**NSLPP MEETING HELD ON 07/05/2025****Attachments:**

ADDRESS: 11 King George Street, Lavender Bay**APPLICATION No:** DA 270/2024**PROPOSAL:** Alterations and additions to existing dwelling house including partial demolition of dwelling including garage, addition of a pavilion and garage, new pool and alterations to landscaping**PLANS REF:**

OWNER: Martin Ulrich Kronberg & Lauren Patricia Gilbert**APPLICANT:** Madelaine Blanchfield Architects Pty Ltd**AUTHOR:** Thomas Holman, Senior Assessment Officer**DATE OF REPORT:** 03 April 2025**DATE LODGED:** 23 October 2024**AMENDED:** 20 March 2025**RECOMMENDATION:** Approval

Figure 23 – Annotated Proposed Cross Section, DA 502 Rev D

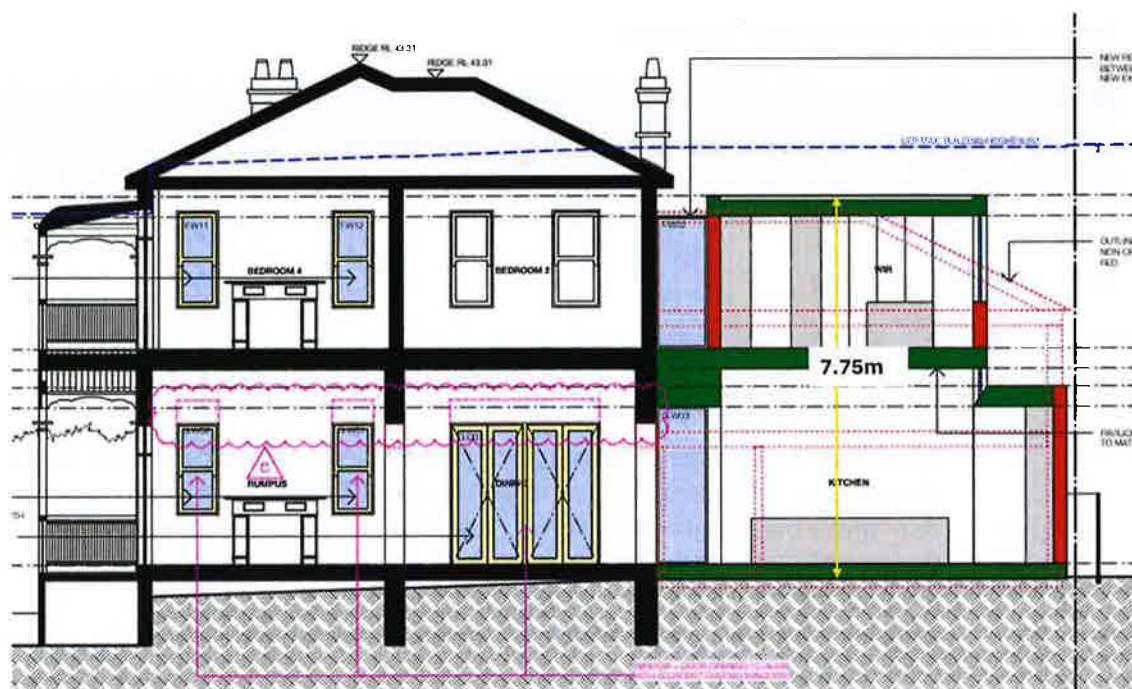
COMPLIANCE TABLE Principal Development Standards North Sydney Local Environmental Plan 2013			
Site Area - 751m ²	Proposed	Control	Complies
Clause 4.3 – Heights of Building	7.75m	8.5m	YES

Figure 24 – Proposed Shadow Diagram 21 June 9am

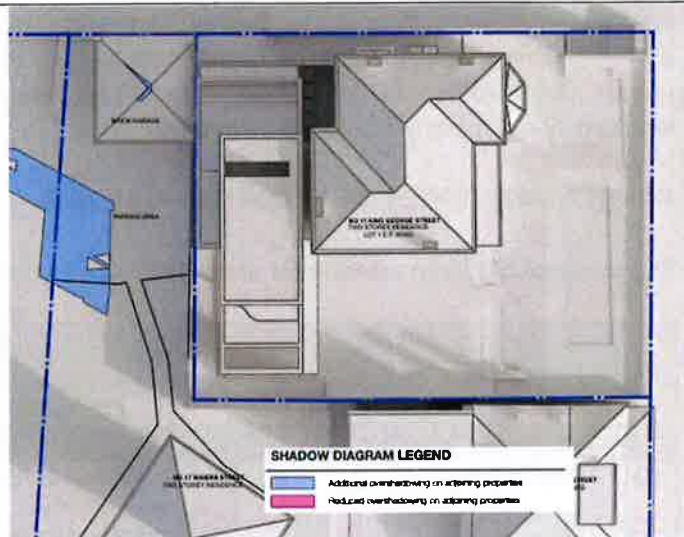
1.3.7 Solar Access	Yes	<p>The shadow diagrams for mid-winter confirm additional shadow will impact the existing car parking area and setbacks of the adjoining 17 Waiwera Street. 17 Waiwera Street is a two storey apartment building comprising of four units.</p> <p>9am</p>

Figure 35 – Existing Area Calculations, DA.601B Rev B

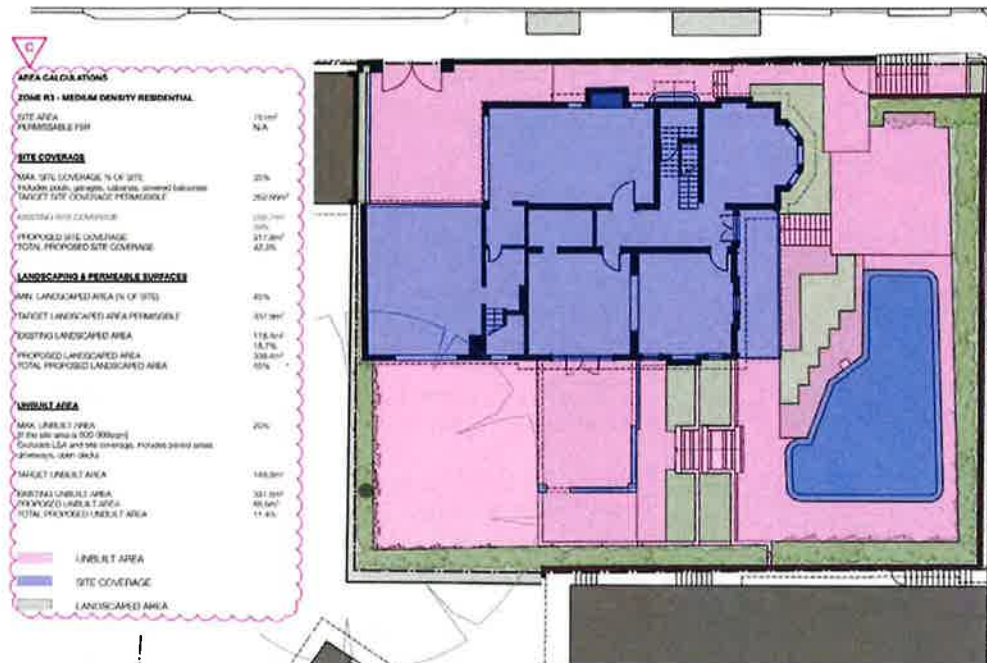
1.5.6	Landscape Area	Yes		Control	Existing	Proposed	Compliance
				Site coverage Max 35%	292.7m ² 39%	317.8m ² 42%	No – merit assessment
				Landscaped area Min 45%	118.4m ² 16%	338.4m ² 45%	Yes
				Unbuilt-upon area Max 20%	339.9m ² 45%	94.8m ² 13%	Yes
				The development has a positive outcome removing large areas of paving and artificial grass for a grass lawn and other plantings substantially improving the landscaped area and achieving compliance with the un-built upon area.

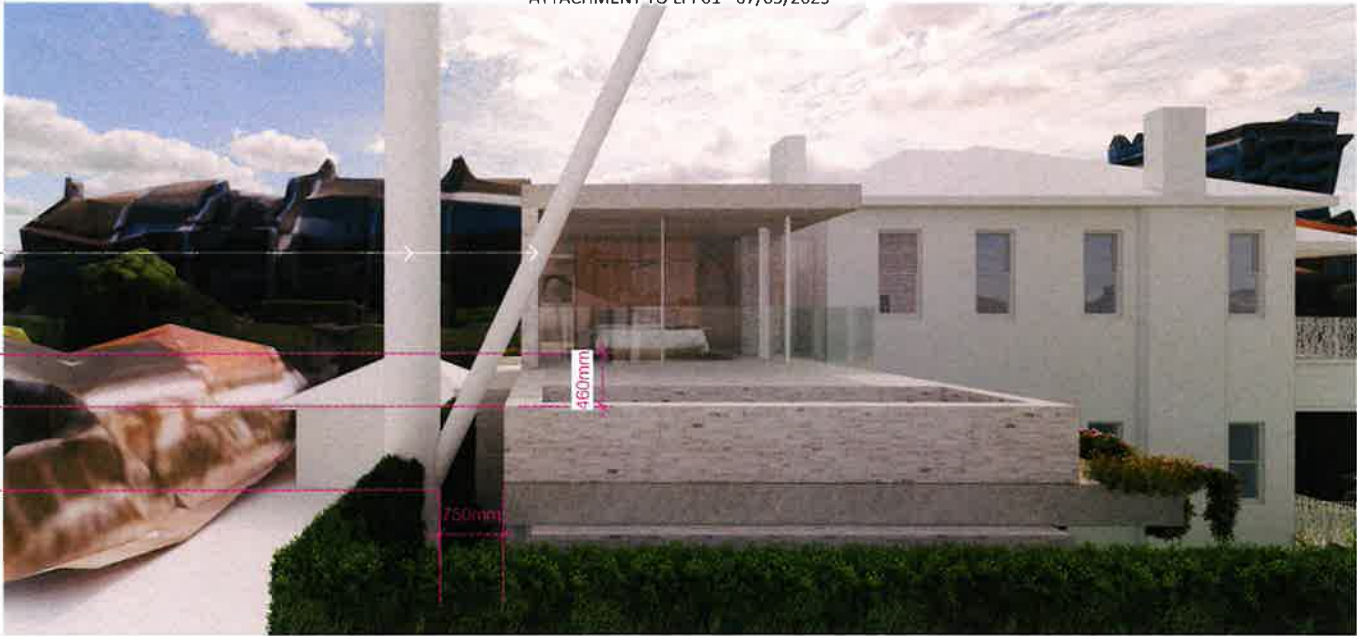
'This proposal cannot be supported in its current form. The major encroachment into SRZ/TPZ of T1, T2, & T3 - 3 x mature native trees to 20x14m is not supportable. The arborist has failed to provide evidence that such encroachment could be supported, seemingly suggesting that a layer of geotextile fabric under slab will adequately resolve any issue posed by the proposed works within the SE corner of the subject site. The arborist has also failed to consider any pruning to these trees, likely to be considerable given proposed works, Proposed replacement canopy planting is considered inadequate. Any amended proposal shall be required to address the above issues, and will likely require a substantially reduced or realigned structure within the SE cr. It is also noted that the lodged survey is over 13 years old.'

It is also noted the design of the first floor has been amended to provide improved clearance between the addition and a Tree T1 allowing future growth of the tree and trunk/crown movement.

Planning Comment: The Applicant in response has submitted additional information including an updated Arborist Report plus root mapping. To date no further comment has been received on the amended plans and additional information provided, however, upon receipt of the additional information there is sufficient reason to support the proposal for the following reasons.
